# TOWNSHIP COOPERATIVE PLANNING ASSOCIATION

Re: Variance Request - Section 2 – Oronoco Township

Request: An application for variances to the criteria for the construction of an accessory building in an R-1; Low Density Residential District. The applicant wishes to replace an existing accessory structure with a new structure that is both larger and taller than allowed by the ordinance as well as being closer to the road than allowed by the ordinance.

### New Site Plan.

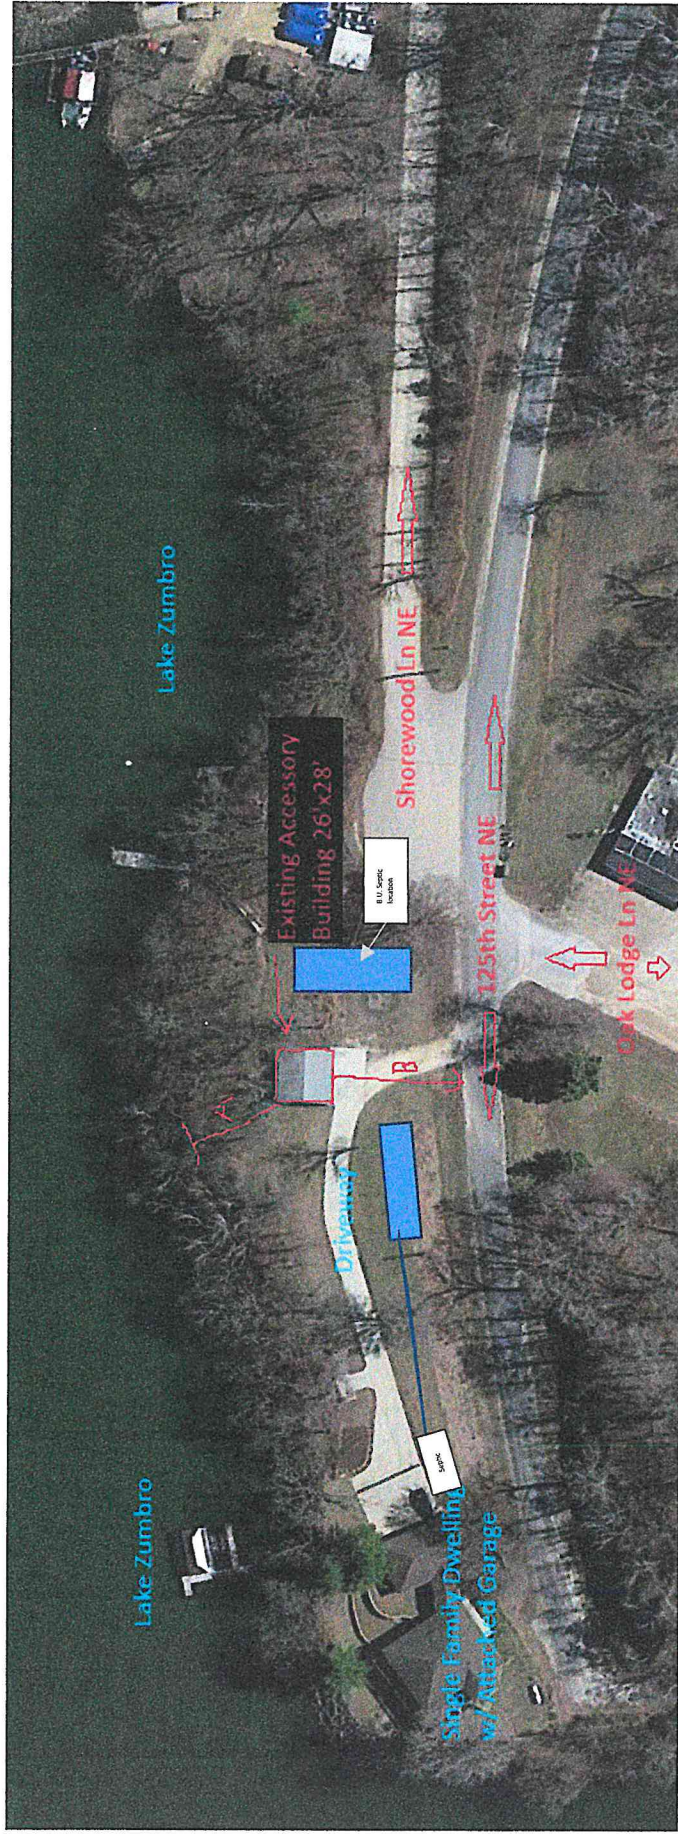
*There may be other potential locations for the proposed structure and the siting of the structure (possibly at a different angle) may change the needed setback variance. However, based on the setbacks and proposed location on the attached map the proposed structure would require a variance of five feet to the front yard setback which is reasonable.*

Distance A from building to Lake Zumbro waters' edge = Requesting Variance to allow 30 Ft

Distance B from building to 125<sup>th</sup> St - centerline of existing road = Requesting Variance to allow 75 Ft

**Existing Structure**

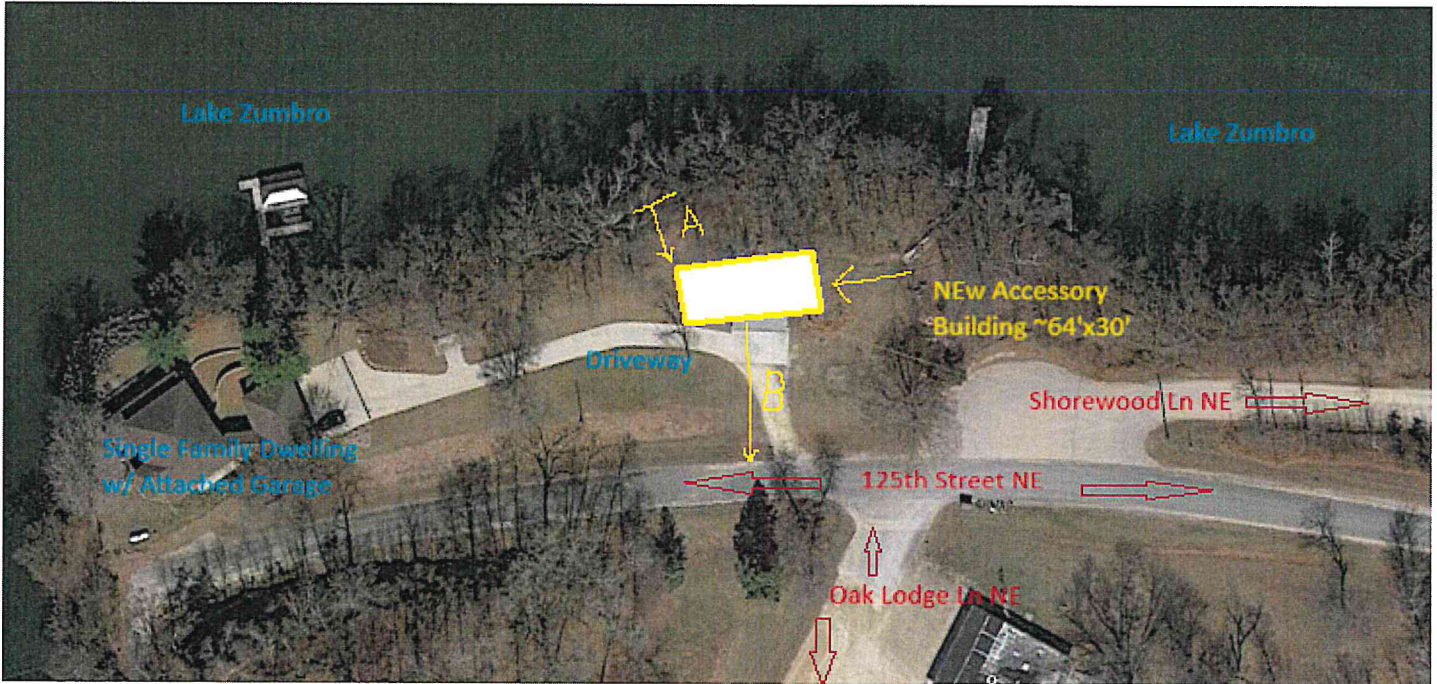
1. Repair the existing structure without a variance,
2. Construct the new structure to meet all setbacks and underlying zoning requirements. See the image below. It appears there are at least 2 alternative building options (or more) that would meet the OHWL setback of 75ft. Slight modifications to the existing driveway may be necessary, but it’s very clear there are options to build on the site that would meet the shoreland setback standards without the need for a variance to the shoreland structure setback.
